**A303 Amesbury to Berwick Down  
(Stonehenge) Wiltshire  
TR010025**

**Wiltshire Council Response to  
Examining Authority's (ExA) Second  
Round of Written Questions**

Drawing Title: DTA 5 COMPARISON

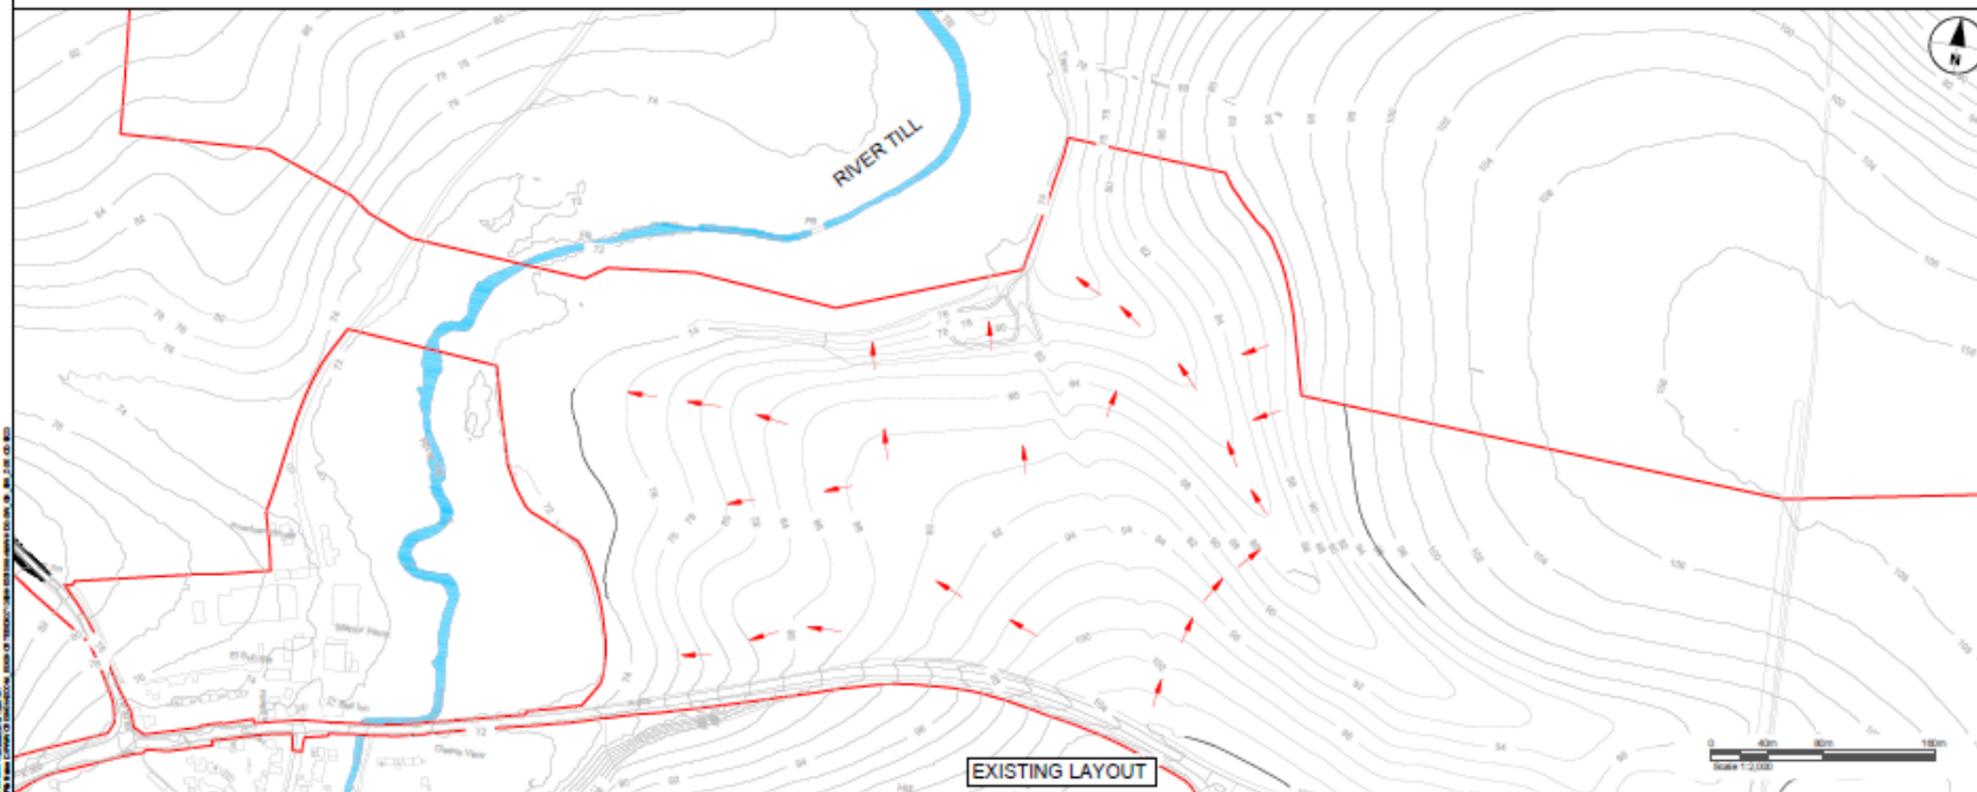
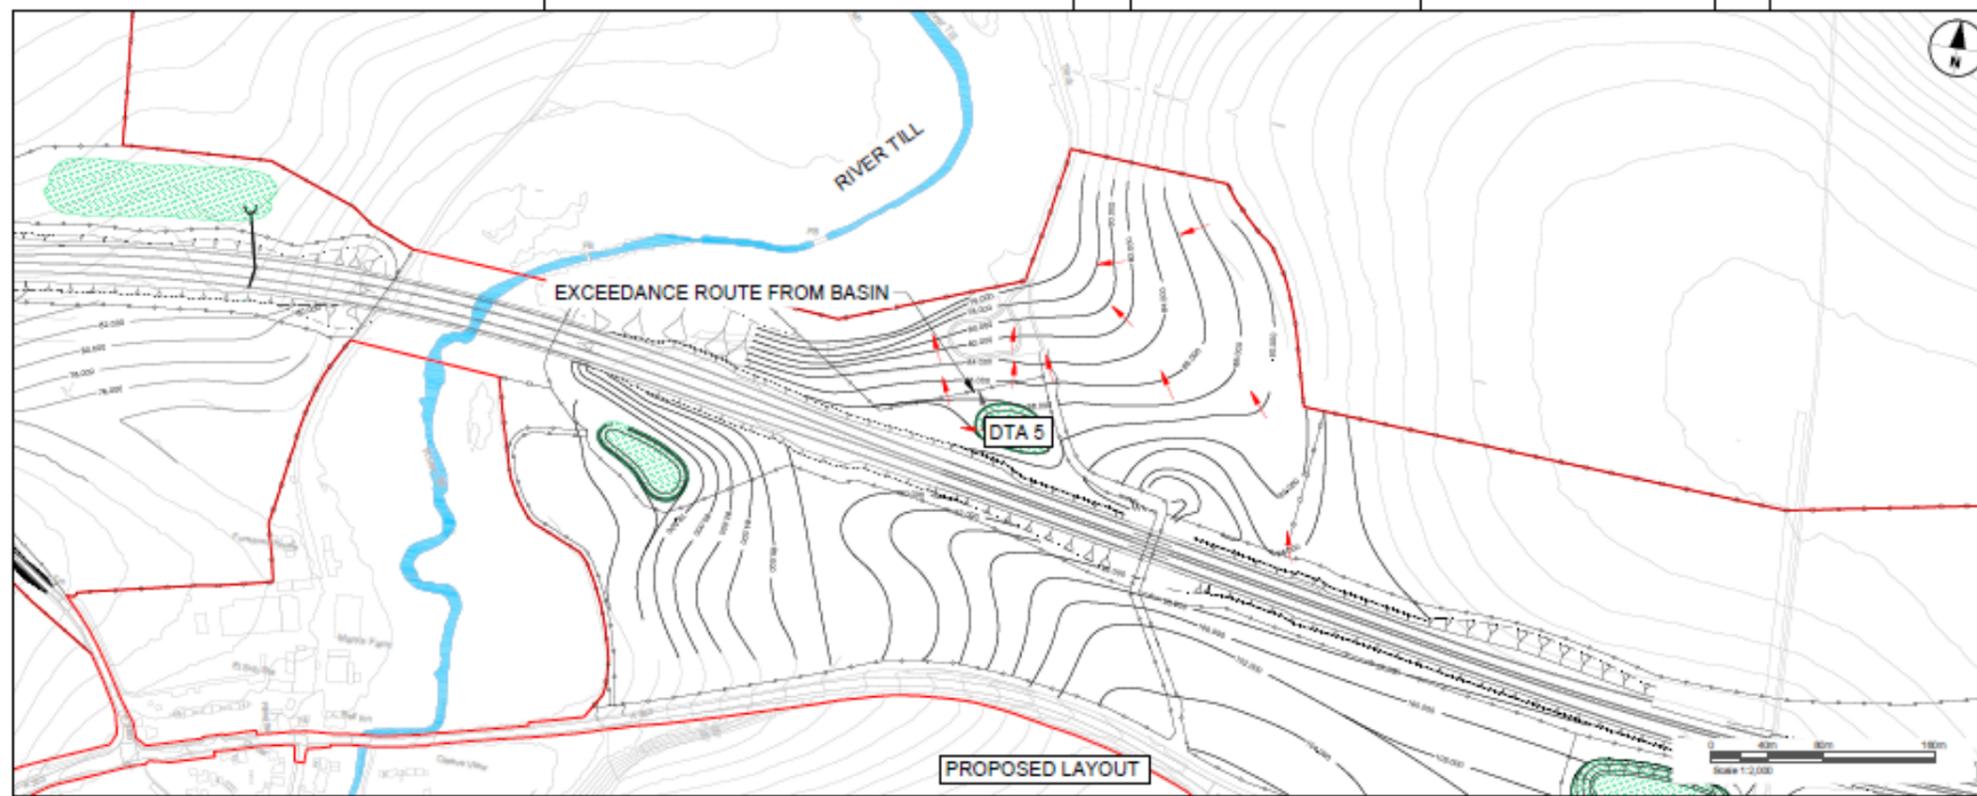
Section	Discussion
3.1	The second bullet suggests the scope is to define, if possible, the storm return period scenario that would result in highway runoff overtopping the drainage treatment areas (infiltration basins). From reading the report there is discussion regarding the percentage climate change that would be required to fill the basin which is designed with a 300mm freeboard above the 100+30% CC rainfall event.  We require evidence that the sizing of the DTAs is based on an assessment of a range of storm durations (which will have significant effects on the volume of storage required) and not just one otherwise the document does not provide the evidence required. Either the narrative within the document is required to be updated to provide this information or additional work is required to ensure that the scheme works as stated.
General	We cannot conclude if the statements made throughout the report are justifiable without evidence that multiple storm durations have been considered in the drainage design. If multiple durations have been utilised in the analysis, we consider that the findings are sound and the proposal is acceptable (however see specific point below that needs addressing first).

6.3	Also see comment 1B 3.7.13 in table 1. It is recognised that the design is still at a concept level, however there is a lack of information to understand how DTA1 fills. Given that the invert of DTA1 is the same as the ground outside of the DTA and therefore the connection to the road surface water system will either need to be below the DTA (conceptually this does not appear to work) or it will need to be at ground or above ground level (which as a concept works as long as it is correctly represented in the hydraulic model at a later stage). Even if this has not been designed out, a narrative is required to clearly explain the assumptions of the design.
